# SCH STAGE 1 / CCCC

## PUBLIC DOMAIN & LANDSCAPE

### RESPONSE TO SUBMISSIONS REPORT

SSD-10831778  
14 September 2021  
APPENDIX No. 01

SCH1/CCCC deep soil

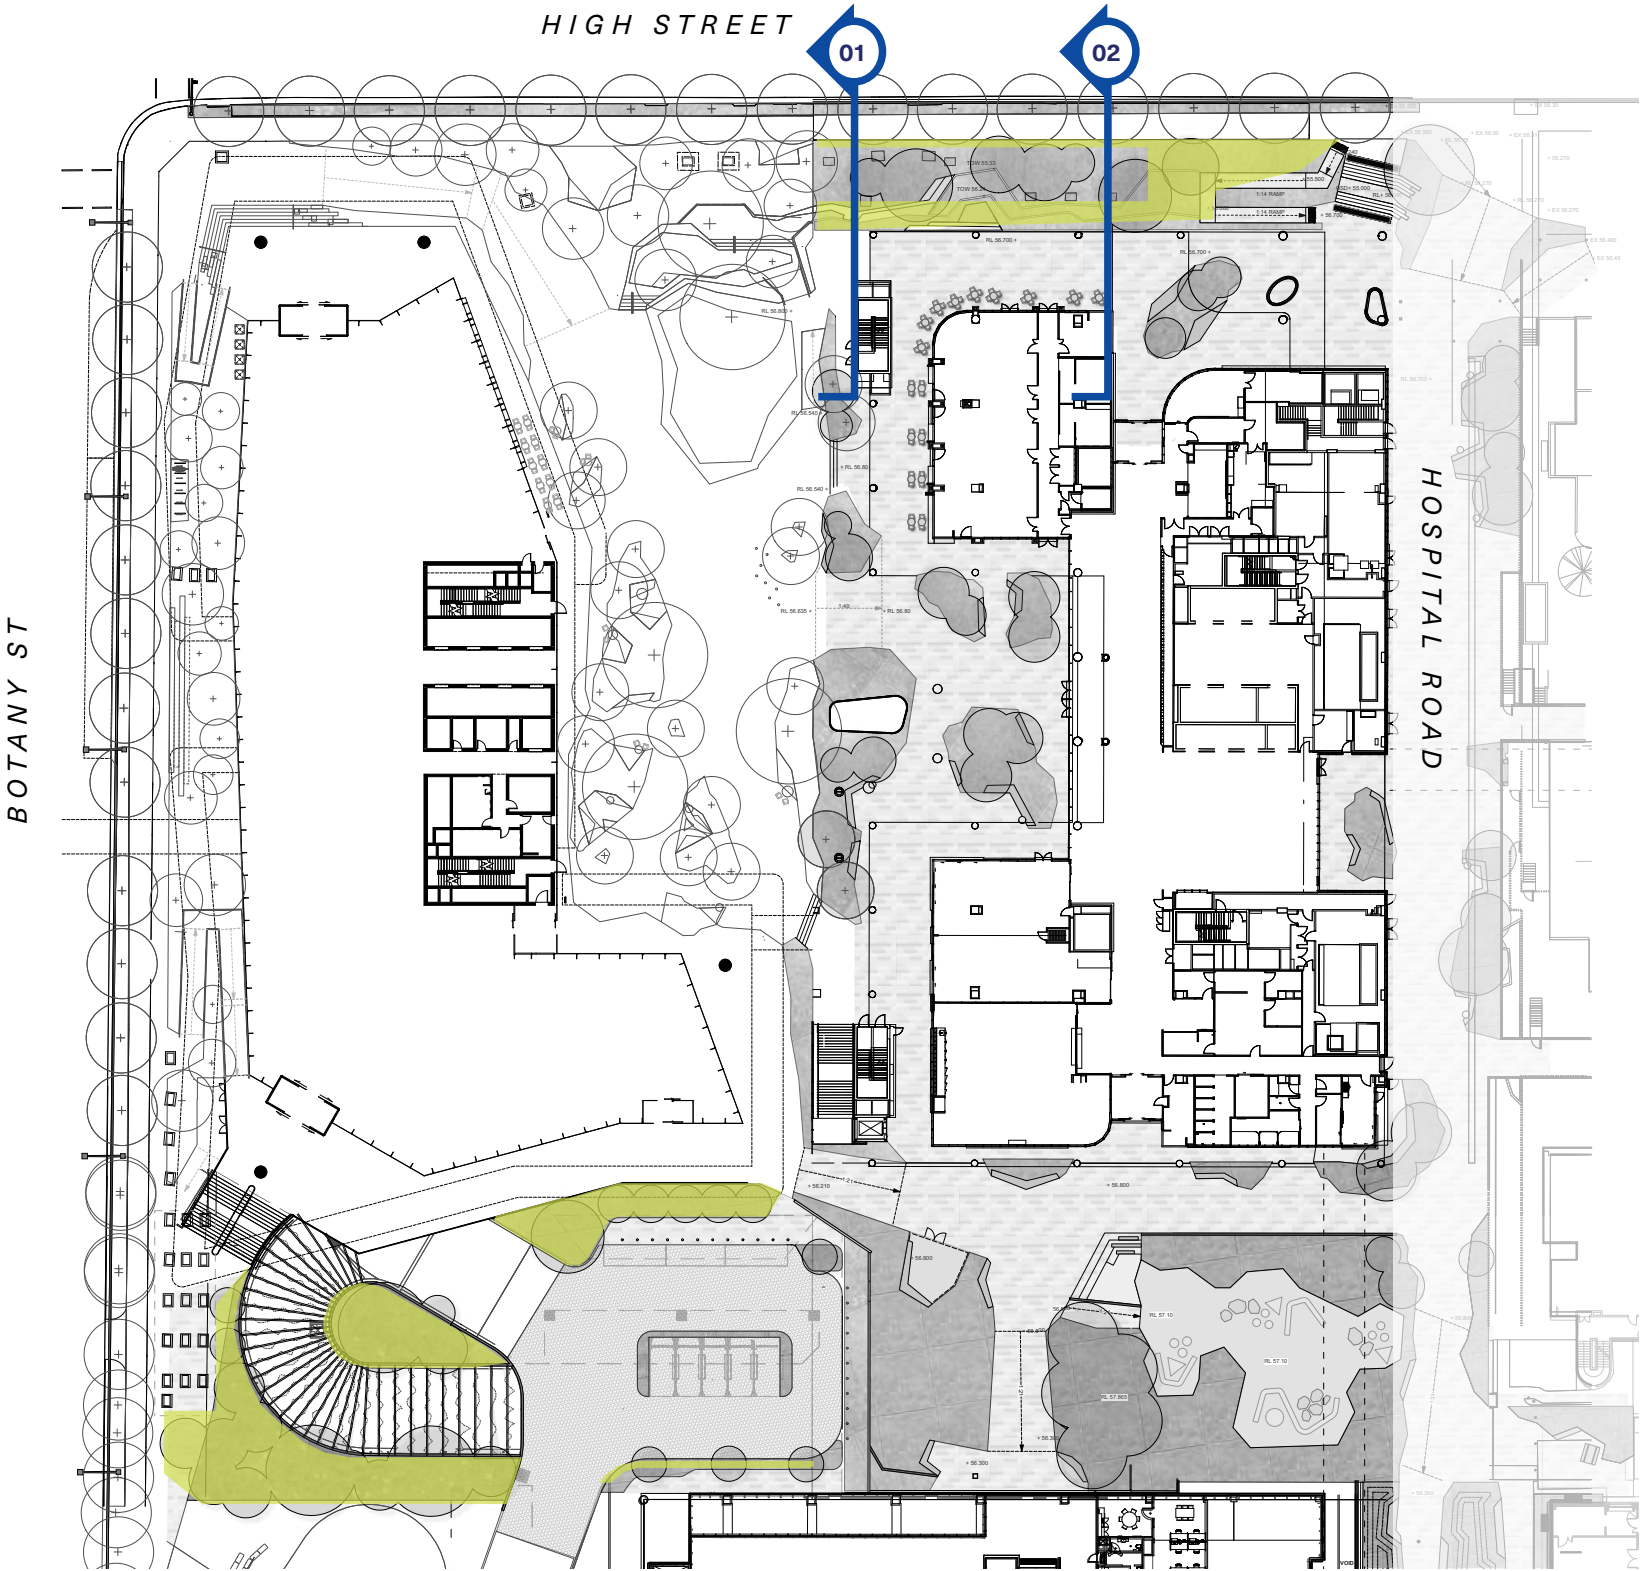
*The north facing ground level plaza and the overall landscape and planting themes are generally supported. However the location of the proposed deep soil zones above a stormwater culvert along High Street and in the leftover areas around vehicular ramps to the south of the HTH building are unsatisfactory outcomes and do not satisfy the intent of deep soil provisions, which are to provide consolidated landscaped areas that people can enjoy that allow large trees to prosper. Further, areas with structures underneath, including culverts are not considered to be deep soil zones.*

*Significant benefit would be realised if deep soil areas were provided in the plaza. This would permit larger trees to be planted to provide shade and contribute to tree canopy requirements. It is also noted that one of the larger trees proposed in the child play area would not be possible due to the low clearance of the pedestrian bridge that crosses over the play area.*

The existing stormwater infrastructure, coupled with the building infrastructure, provide limited opportunity for deep soil on site. The design team understands the opportunities of deep soil but also recognise that tree planting over the culvert is possible due to depths

The hospital site is constrained by the building function, particularly with the B1 emergency department below, to provide significant deep soil within the ground floor plaza. The design team will ensure that adequate soil volume, equal to the guidelines provided in the Apartment Design Guide, NSW Planning 2015, and the City of Sydney Landscape Code, 2016.

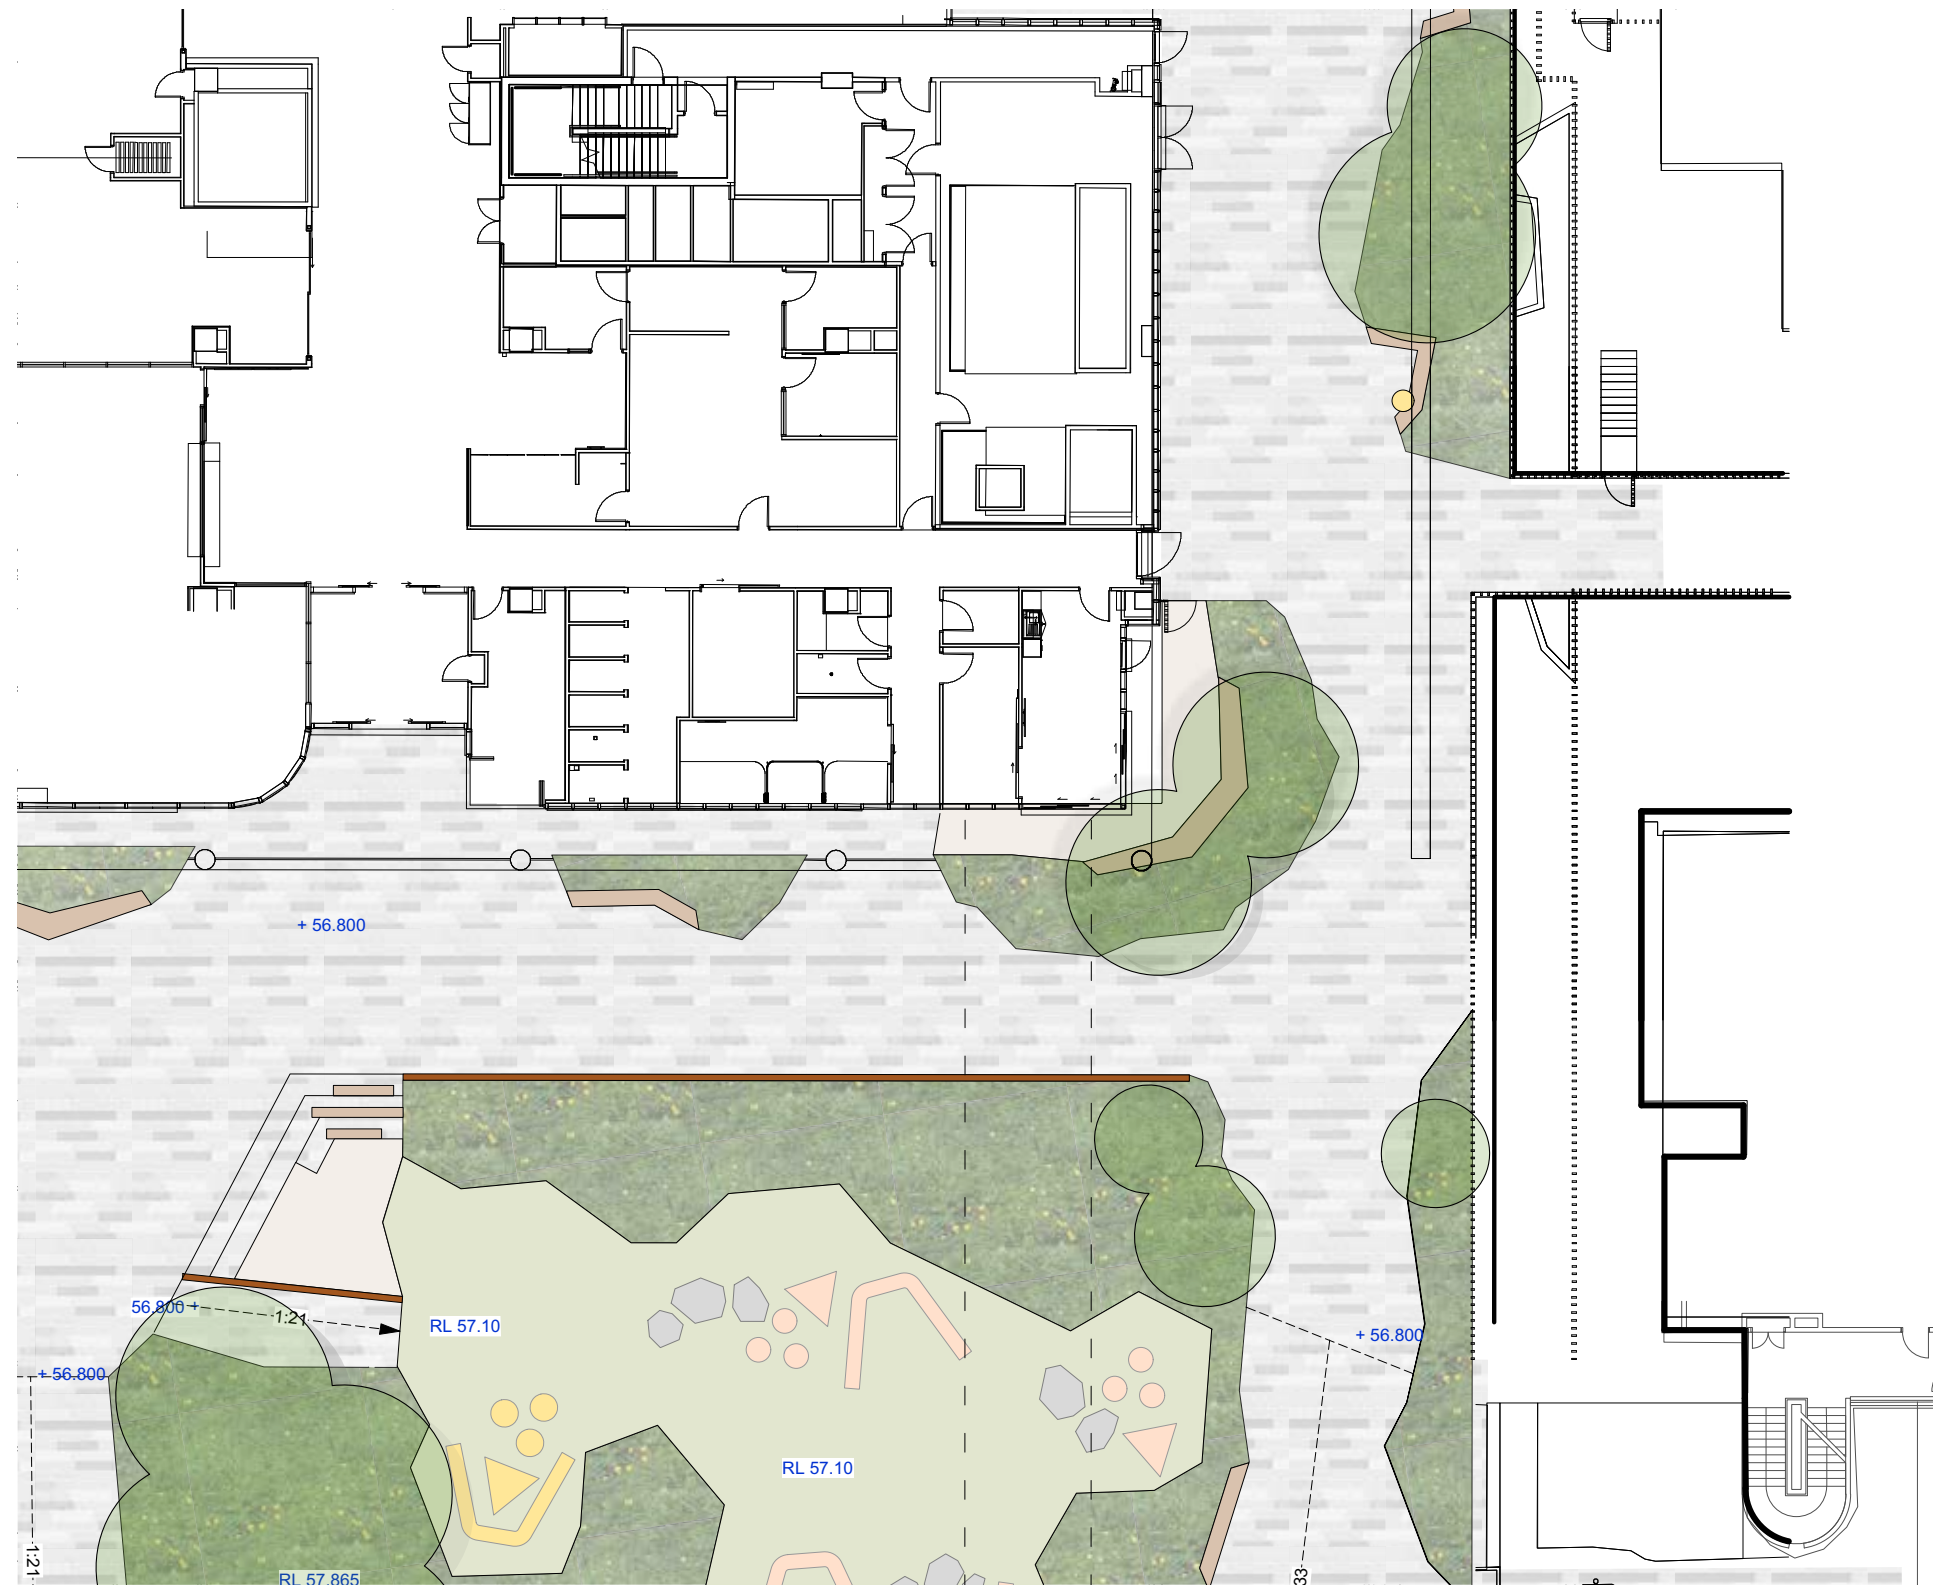
The Department is concerned the children's play area will be heavily overshadowed and visually enclosed by surrounding built forms. The provision of an attractive outdoor space for patients of the Children's Hospital is considered an important aspect of the amenity of the building. Therefore, provide further details, visualisations and hourly solar access studies (incorporating shadowing from the proposed HTH) to demonstrate how a high level of amenity would be achieved to the proposed space. If a high level of amenity is not achieved, consideration should be given to supplementing this play space with additional attractive and safe open space for patients such as utilising the podium roof to create additional open space for patients.

The public realm has been designed to integrate informal play opportunities through all elements of the site. This includes benches, plants, lighting and public art. The design also includes a series of upper level terraces that provide play experiences for patients whilst also catering for increased solar access. (Refer to the architectural report for further information on solar access.)

During the design development stage the space will be shaped to provide opportunities for engaging and diverse experiences to occur for ages 0-18 years, as well as families and caregivers. The design team is also working with Yerrabingin and engaging with local indigenous communities, both elders and children, to develop opportunities for this space to become meaningful and playful, and respond directly to the outcomes of the community.
